NUCLEAR ENERGY INSTITUTE

SUBJECT: Joint Owners Group Air Operated Valve Program Document

**Joint Owners Group
Air Operated Valve Program Document,
Revision 1**

Revision 1

Figure 4-1: CATEGORIZATION FLOW CHART

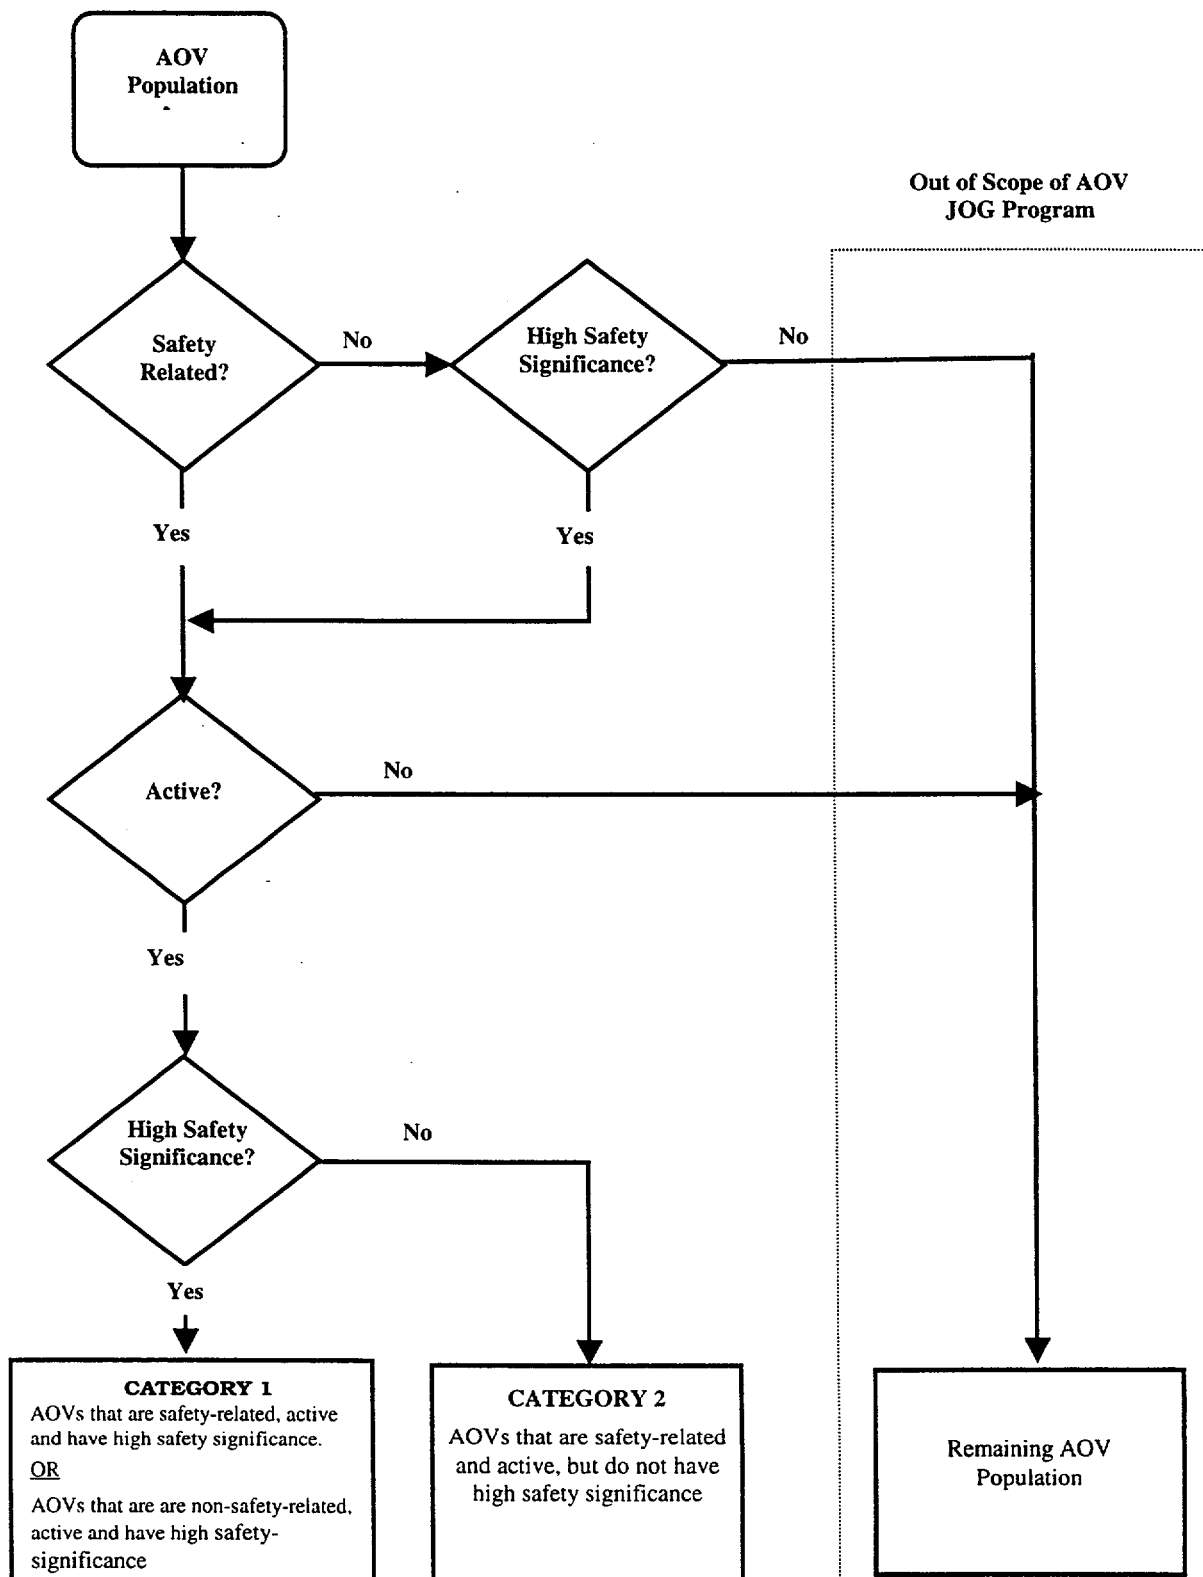
Paragraph 2 of Section 3 (page 4), Footnotes to Table 3-1 (page 5), and Figure 4-1 (page 9) changed consistent with the new definitions.

Figure 4-2: DESIGN BASIS REVIEW METHOD OVERVIEW

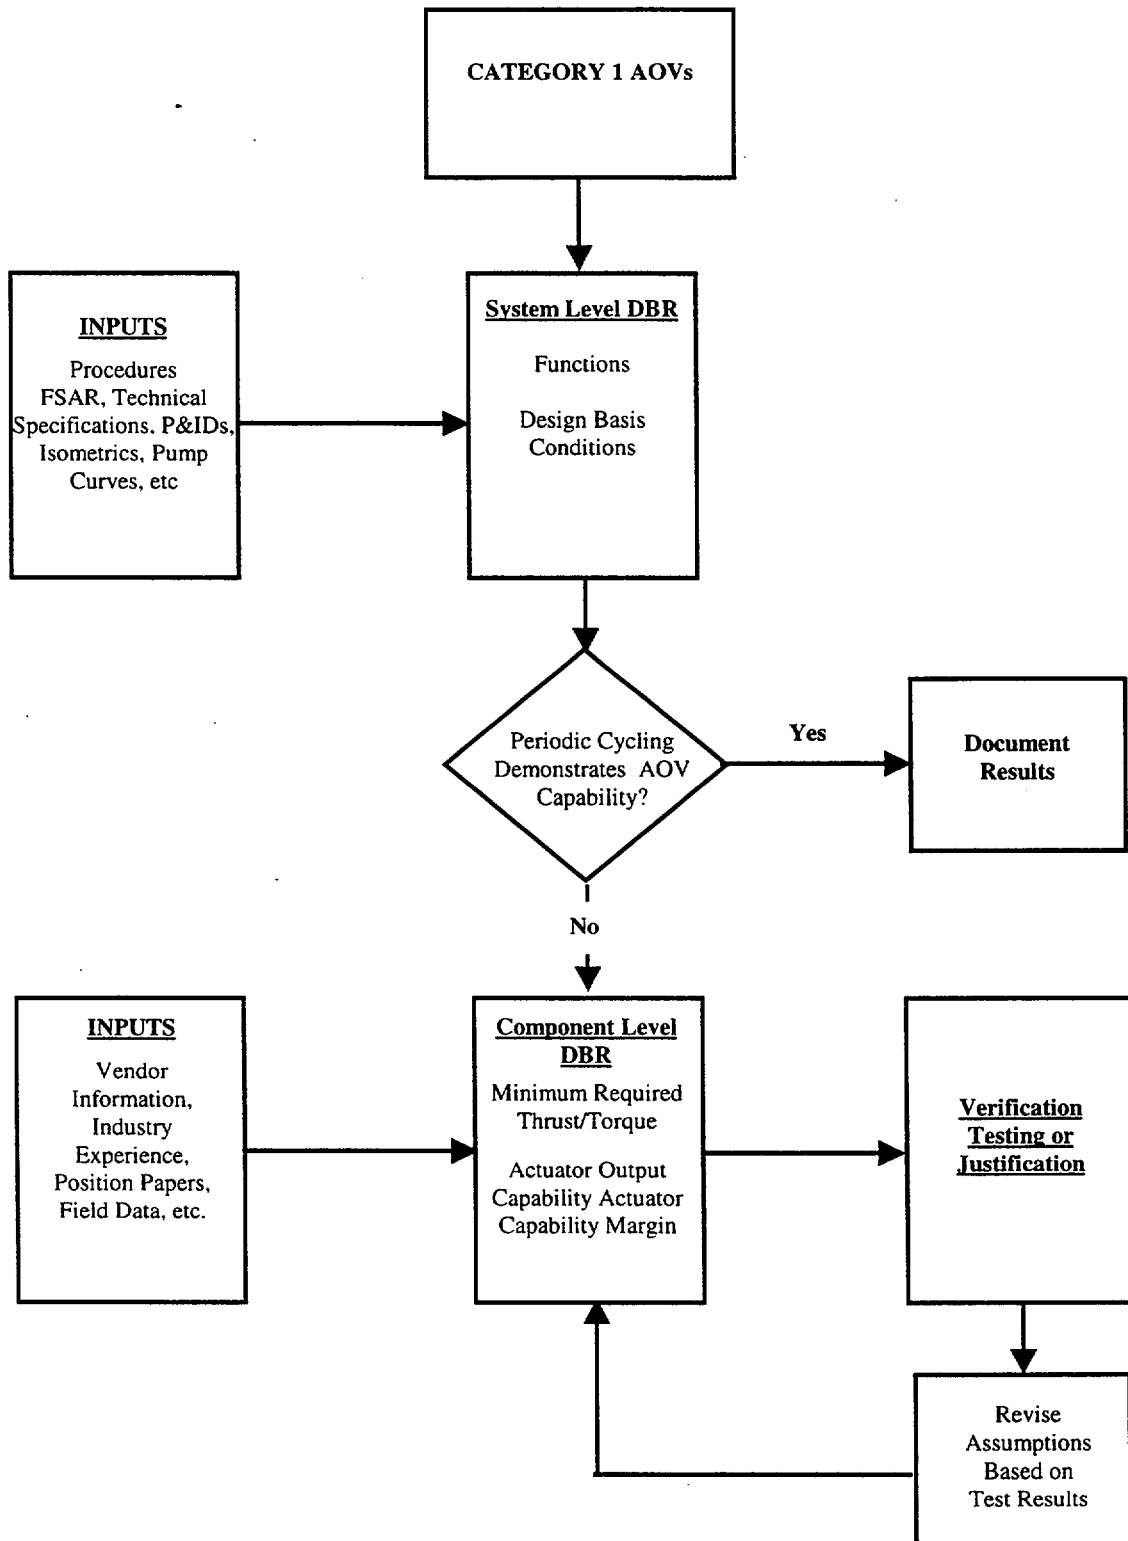
7. Revised Figure 4-2 (page 11) to delete an extraneous reference to an attachment.
8. Revised Paragraph 4.3.3.2 (page 13) to refer to the EPRI "evaluation" guide in lieu of the "application" guide.
